Re: Naval Air Warfare Center (NAWC)

Please find below EPA comments on the Phase III RI Workplan dated January 1995 as it addresses geophysical survey work for Sites 6 and 7.

Enclosure 1
to letter of March 15, 1995

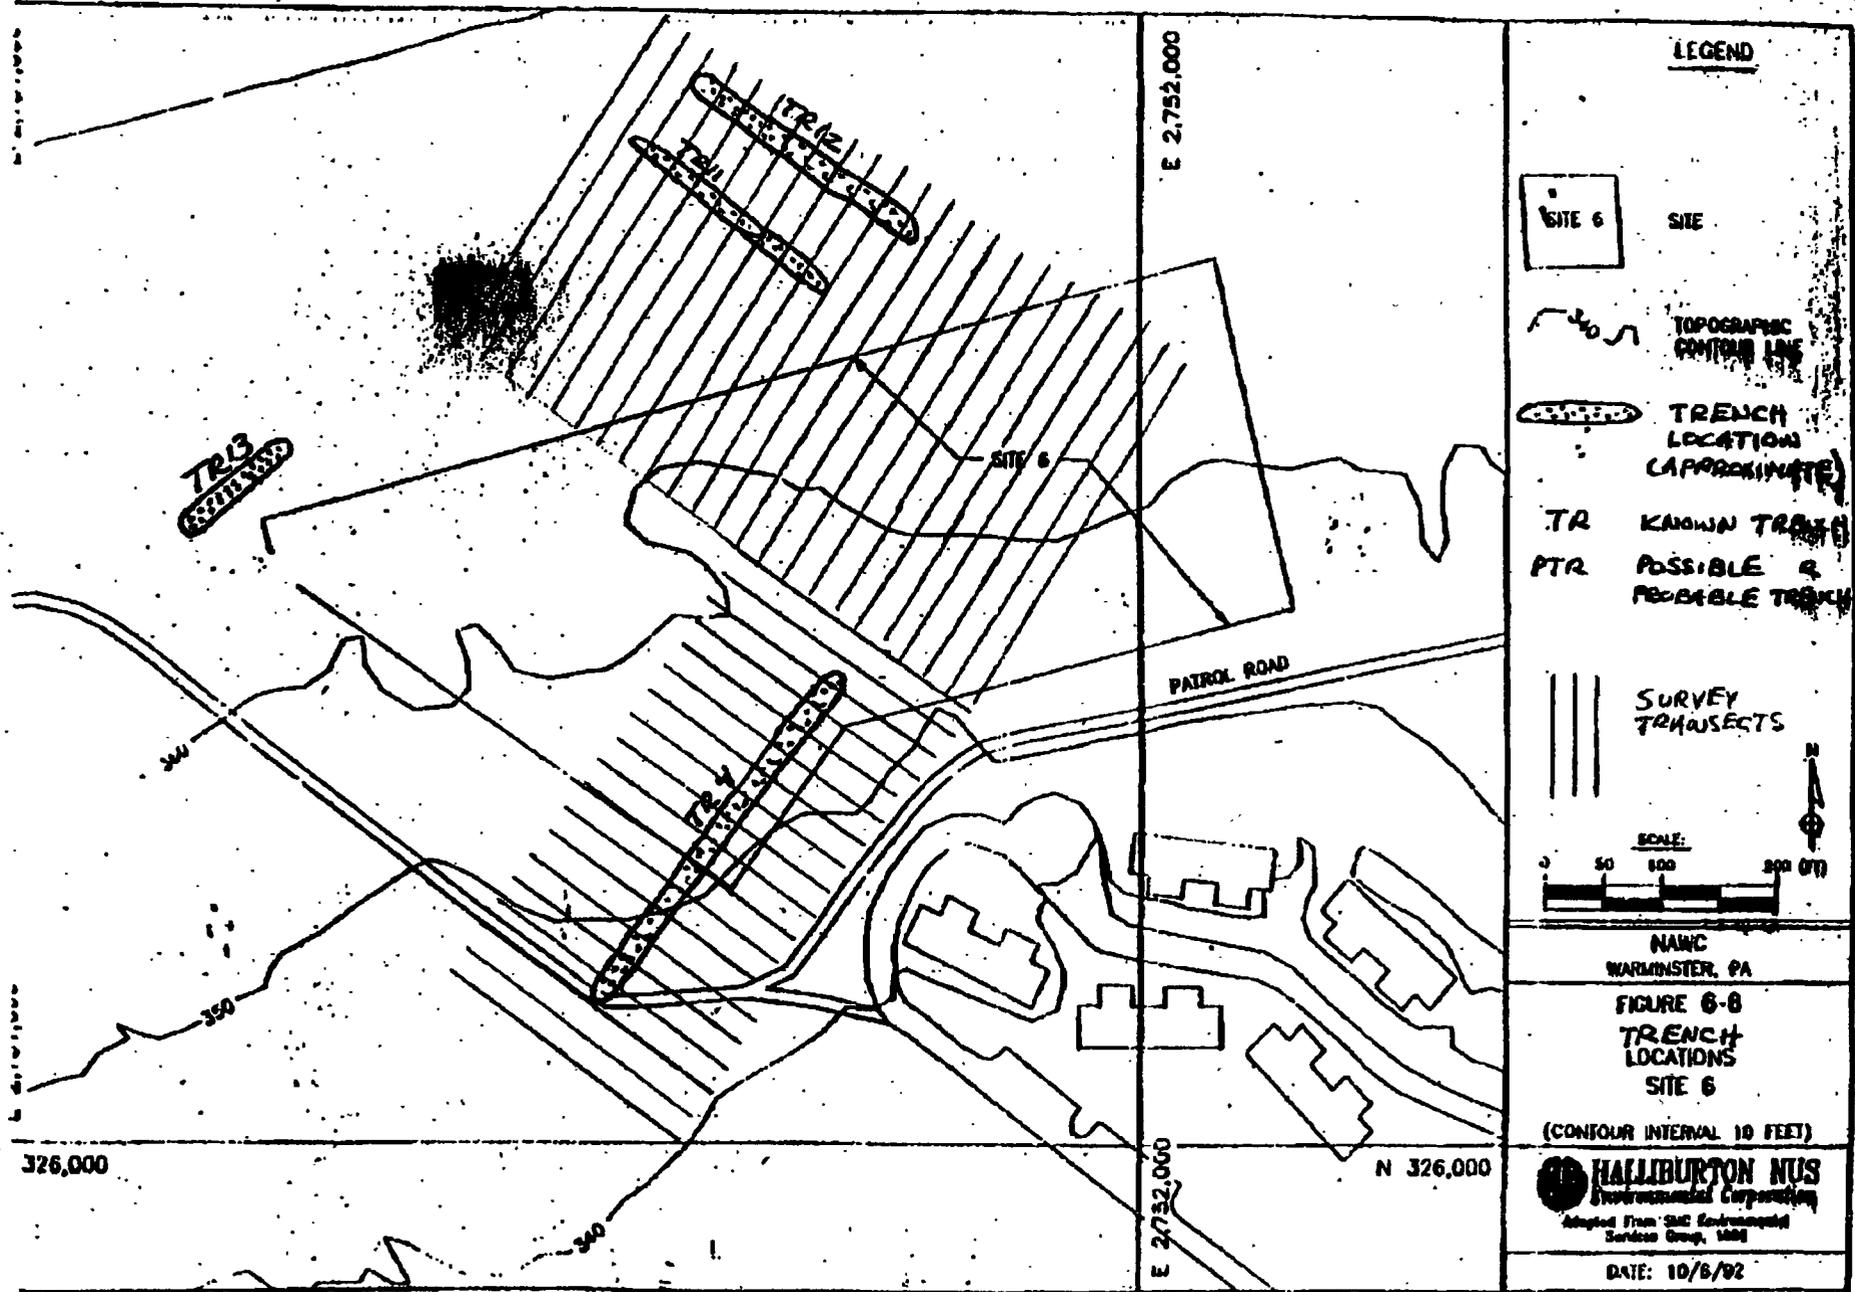
The aerial extent of the survey lines should be expanded to cover the areas depicted on Enclosure 1. The spacing of the transects perpendicular to the trenches should be no more than 25 feet. Where trees or other obstacles prevent such spacing, the goal should be no less than 4 transects per 100 feet.

Transects perpendicular to the trenches should be extended at least 75 feet from each end of the trenches.
